Site: Eagle Ranch MVD

Re: Drainage Ordinance (14-5-2-1) Violations for Erosion and Sediment Control and Trash

No BMP along northern edge of the site.

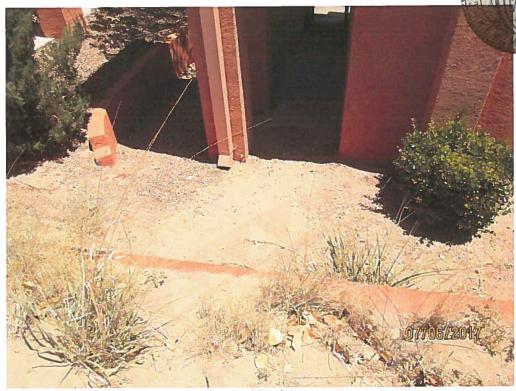
- 1. No BMP to prevent windblown sediment from leaving the site along the northern edge of the site.
 - 2. Windblown sediment in adjoining property to the north.
 - 3. Trash not in a trash receptacle and trash receptacle not observed onsite.
 - 4. No track-out pad/stabilized construction entrance.
 - 5. No sediment BMP to prevent sediment from leaving the site at the cul-de-sac.

1. Install a sediment BMP to prevent sediment from leaving the site along the northern edge of the site as shown on the approved ESC plan.
